Re: Heritage Advice Letter - Modification DA 210293 (2155 Sutton Road Sutton).

Thank you for your enquiry in regards to the heritage status and constraints located within 2155 Sutton Road Sutton on Lot 1 DP 32236. A section 4.55 amendment to modify the existing consent (DA 210293) is being considered. The amendment will add three lots, two within the existing development footprint and one to the east which will assist in the formation of the future road reserve for the Sutton Bypass. This letter provides advice on the effect of the proposed amendment on the recorded Aboriginal heritage sites and AHIP conditions.

Figure 1: Previously Recorded Heritage Sites

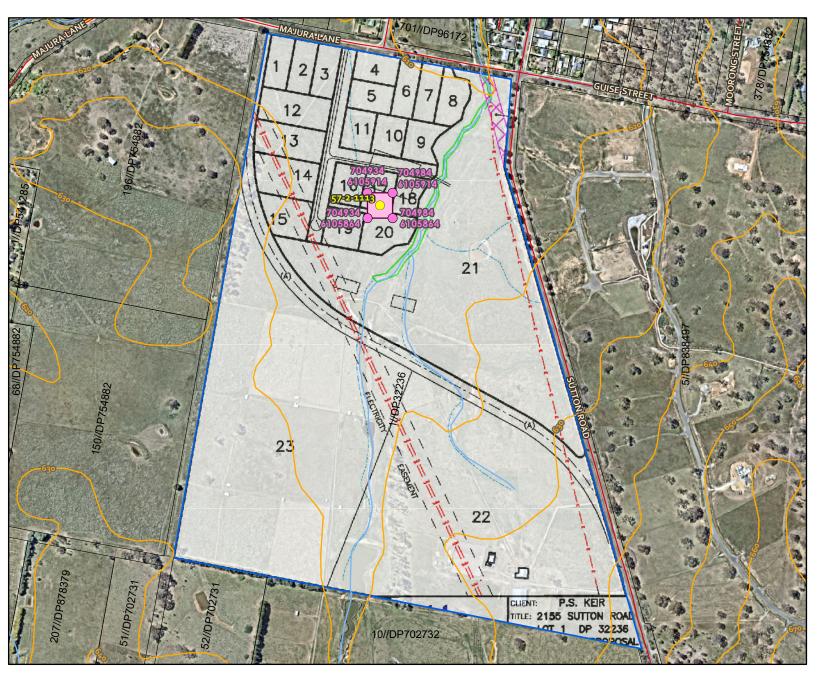
Currently a modification is proposed to the lot layout with an additional two lots within the development footprint and an additional eastern lot. The proposed modified lot layout is shown in Figure 3. The additional two lots are within the development area, where AHIP #5394 has removed all heritage constraints. The additional eastern lot is not within an area of heritage constraint and no impacts will result from the additional lot. The modification will not therefore have any adverse or increased heritage impacts, as the design avoids the remaining two areas of PAD (as shown on Figure 1) which remain within the larger block boundary.

The modified design does not impinge on the Return To Country location of the excavated artefact on the southwestern boundary as shown in Figure 1.

- 3. As development has extended southwards, closer to the two remaining area of PAD it is recommended that the two heritage areas (PADST2 and PADST3) are marked on construction mapping as a no go zone, and that all construction traffic avoids crossing the areas of PAD.

- 4. Temporary barrier fencing should be installed with a 10m buffer at the PAD boundary, or at the southern development boundary to prevent accidental impact prior to works commencing. The temporary fencing should consist of, as a minimum, star pickets with hi visibility flagging.
